## **How do I read this report?**

>  
>Preliminary plans for the Bergstrom Expressway project call for  
>modifying current accessibility at US 183 and Bolm Road, which will  
>negatively impact communities in East Austin, including the Knollwood  
>on the Colorado neighborhood. We oppose this action for the following reasons:

**View C1: 183 N just north of the river - BEFORE**

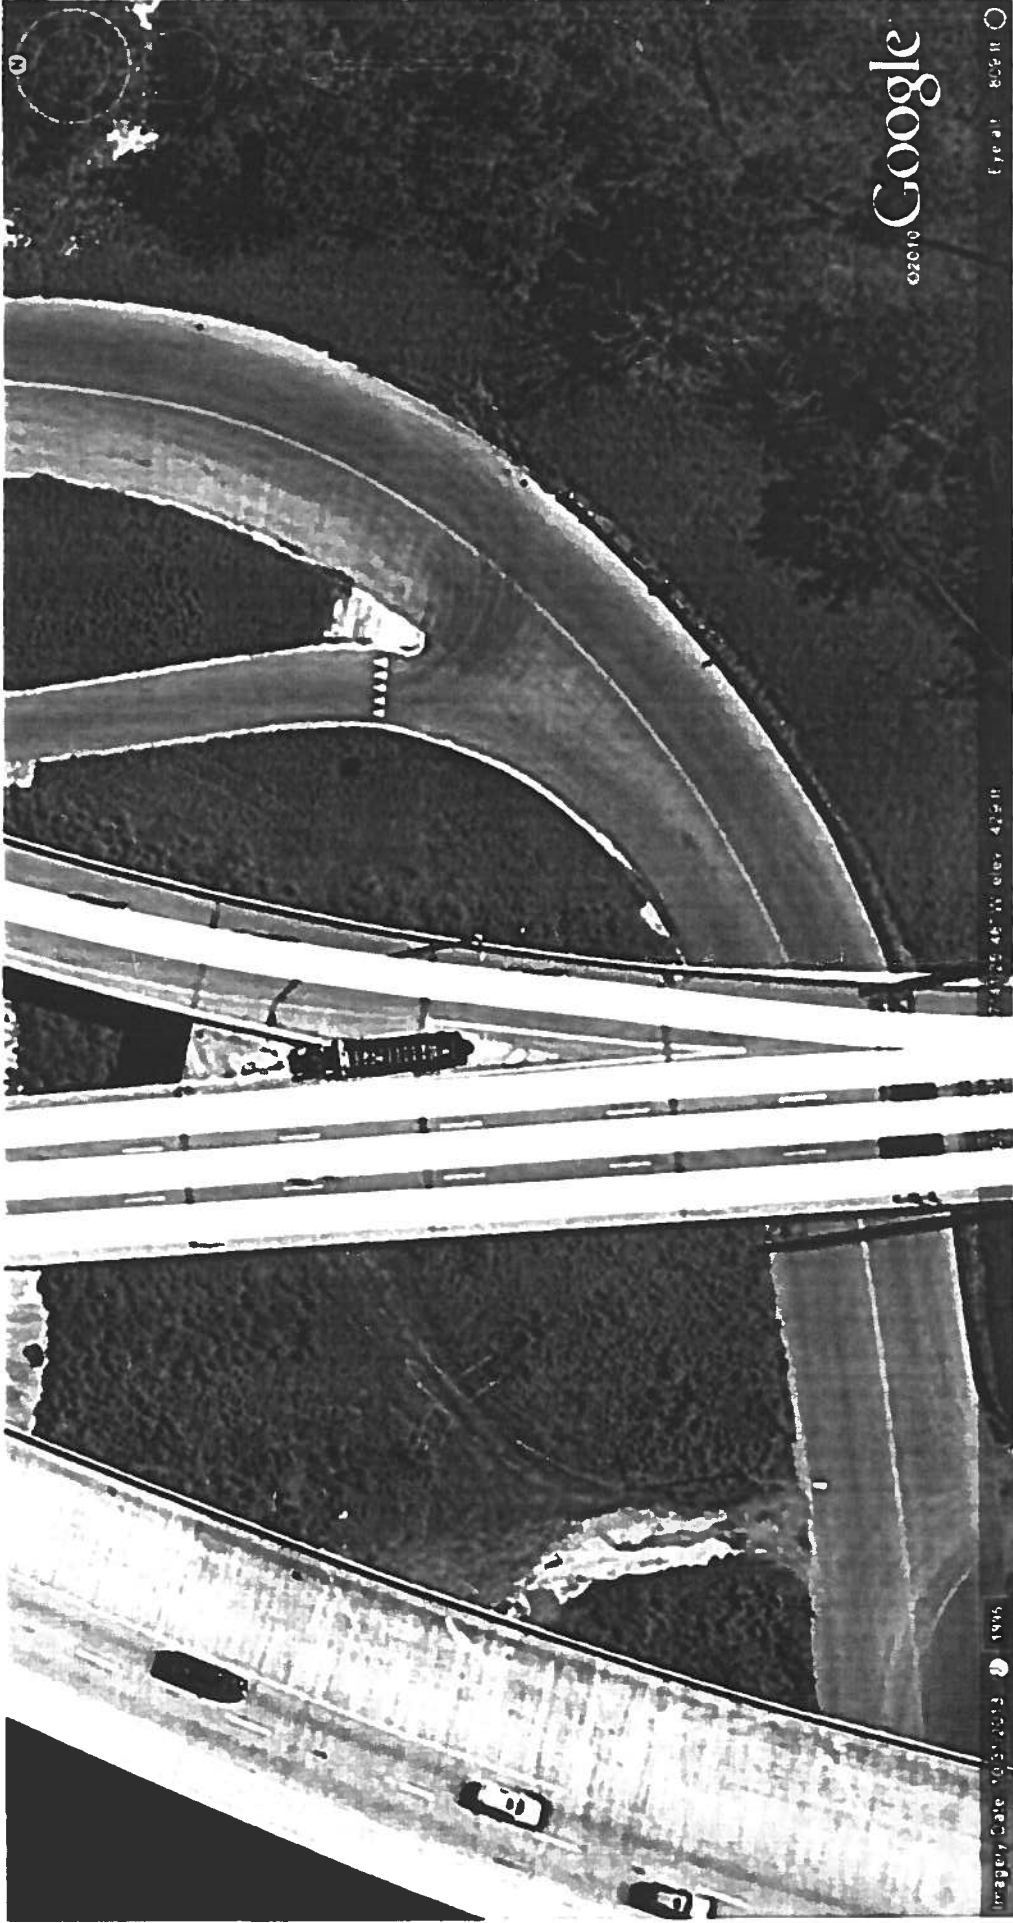
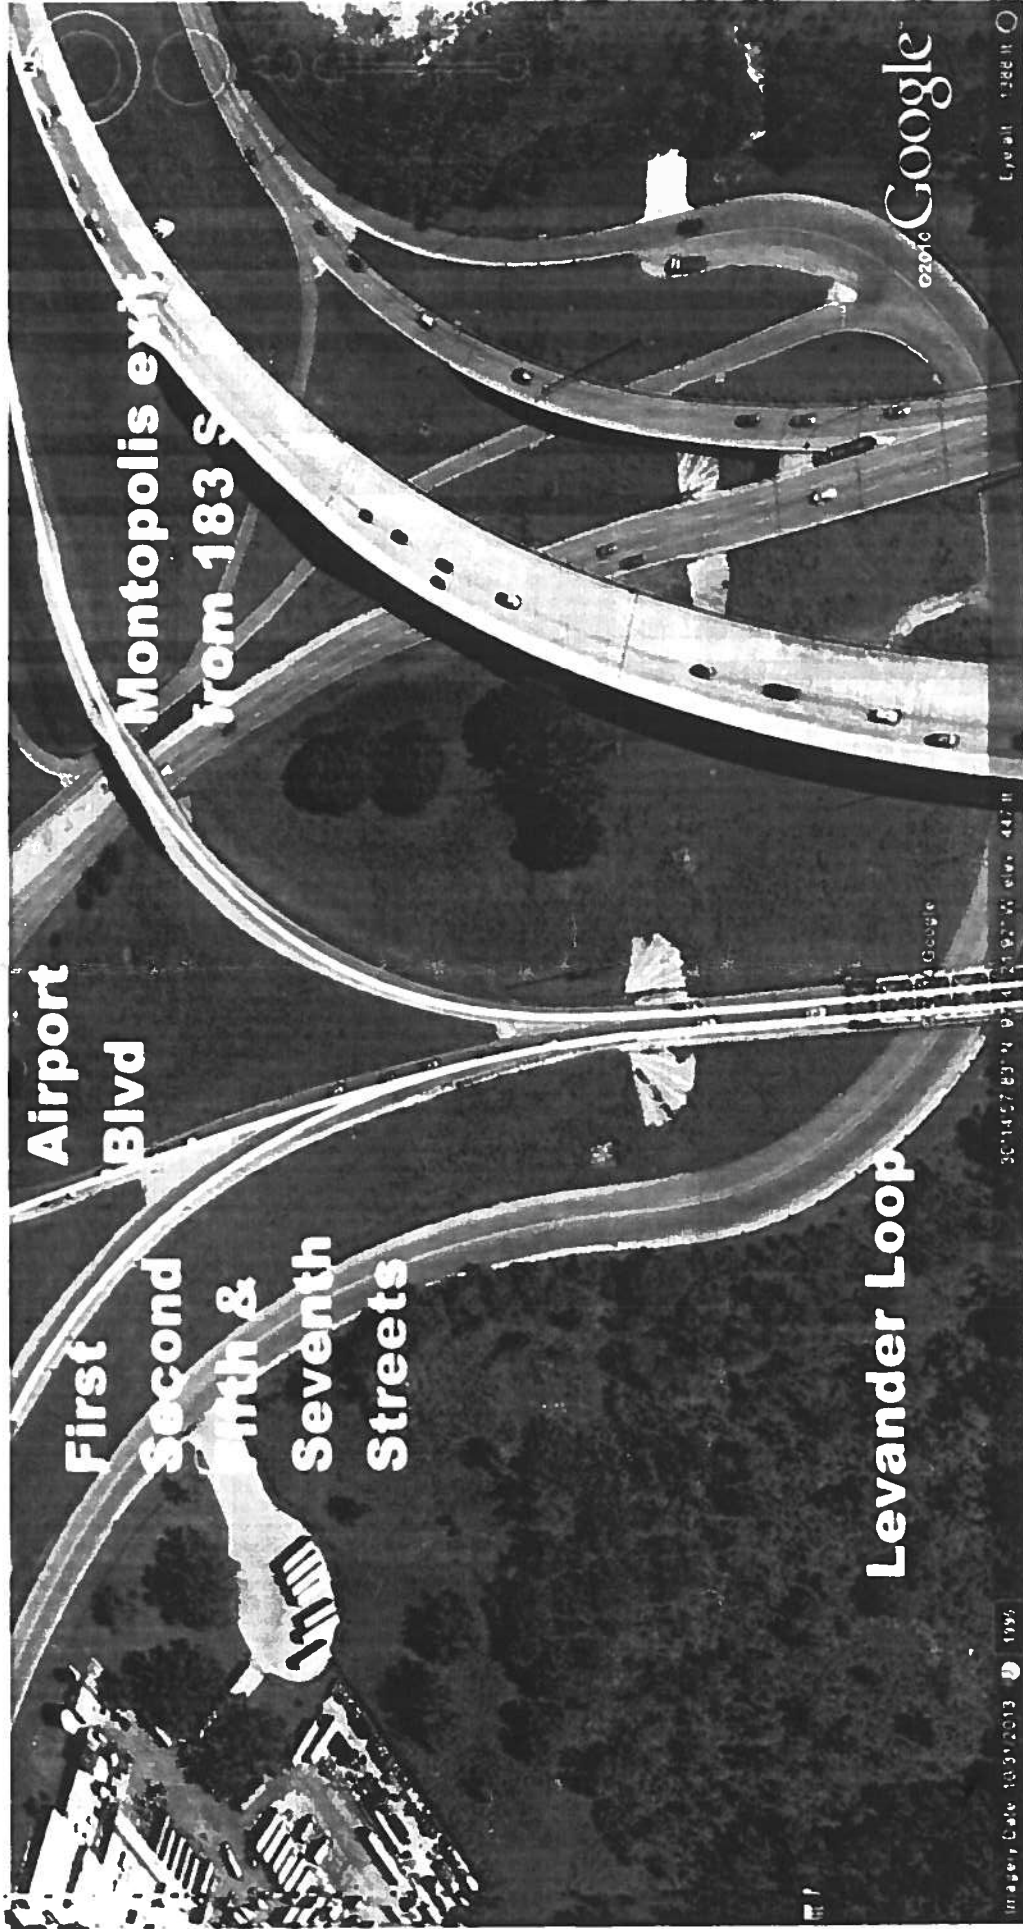
**View C2: 183 N just north of the river - AFTER**

# View D2: 183 S just before the 'old' bridge - PROPOSED

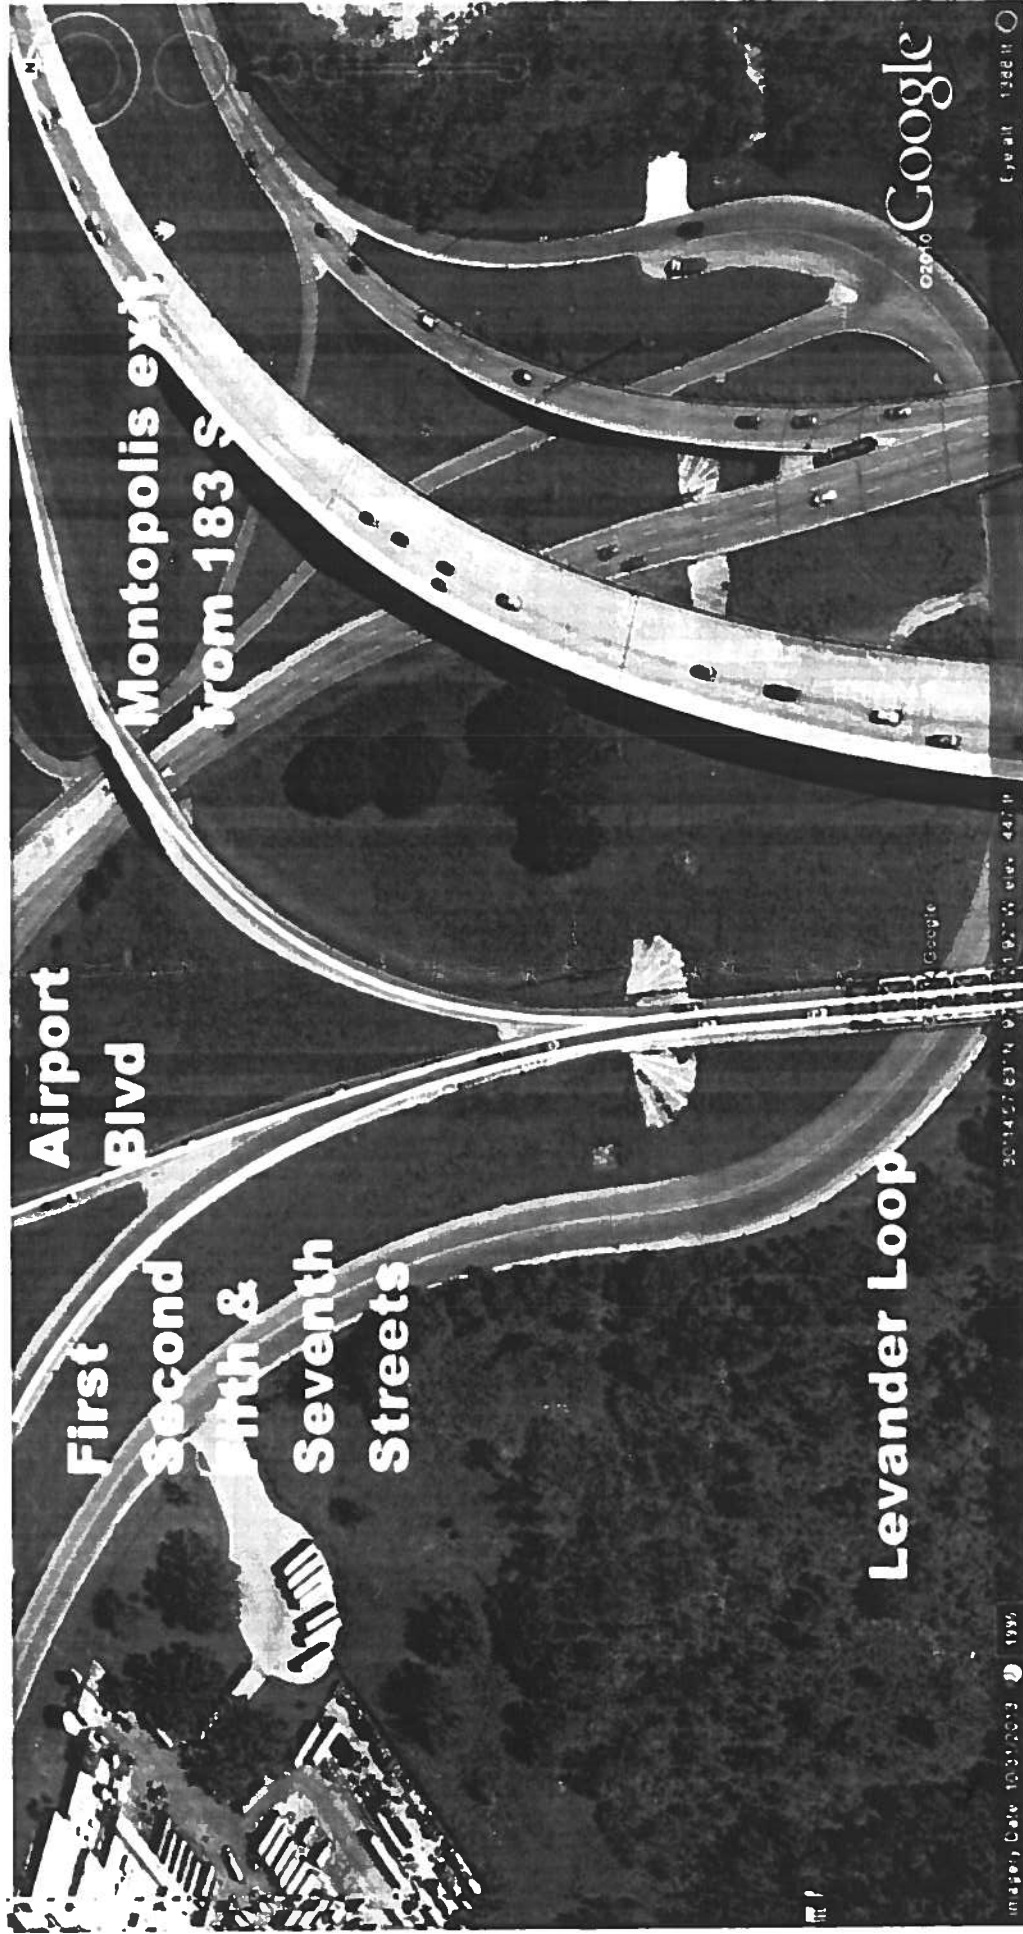
**View D1: 183 S just before the 'old' bridge - PRESENT**
